UNITED STATES PATENT AND TRADEMARK OFFICE

APPLICATION NO.	FILING DATE	FIRST NAMED INVENTOR	ATTORNEY DOCKET NO.	CONFIRMATION NO.
10/784,841	02/23/2004	Bruce Allan Crawford	BC-04	1477
7590	05/22/2006		EXAMINER	
James Addison Barry, Jr. 105 Glenway Point Lebanon, TN 37087			MEISLIN, DEBRA S	
			ART UNIT	PAPER NUMBER
			3723

Office Action Summary	Application No.	Applicant(s)
	10/784,841	CRAWFORD, BRUCE ALLAN
	Examiner	Art Unit
	Debra S. Meislin	3723

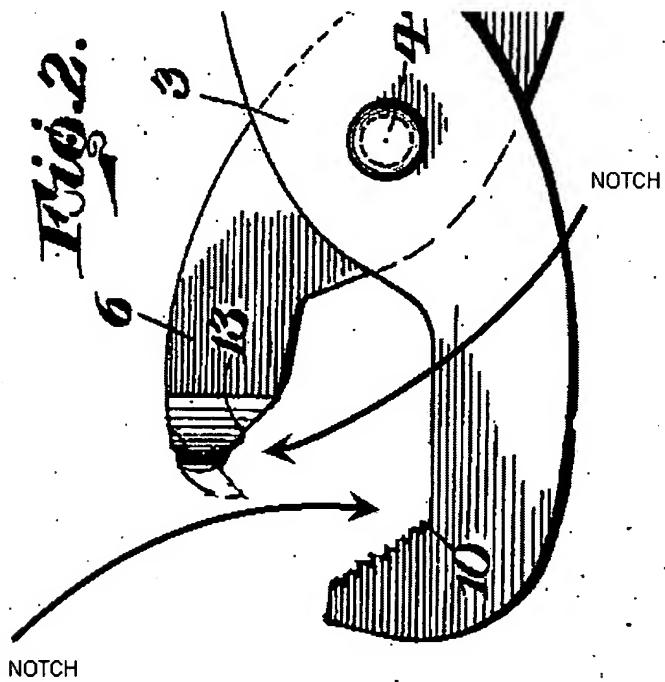
5. Claims 10 and 24-28 are rejected under 35 U.S.C. 102(b) as being clearly anticipated by Nation (1,782,364).

Nation discloses the claimed "notches" as shown below. The device of Nation is also capable of engaging a locknut.

Nation discloses the claimed "notches" as shown above. A recitation of the intended use of the claimed invention must result in a structural difference between the

claimed invention and the prior art in order to patentably distinguish the claimed invention from the prior art. If the prior art structure is capable of performing the intended use, then it meets the claim. The device of Nation is also capable of engaging a locknut.
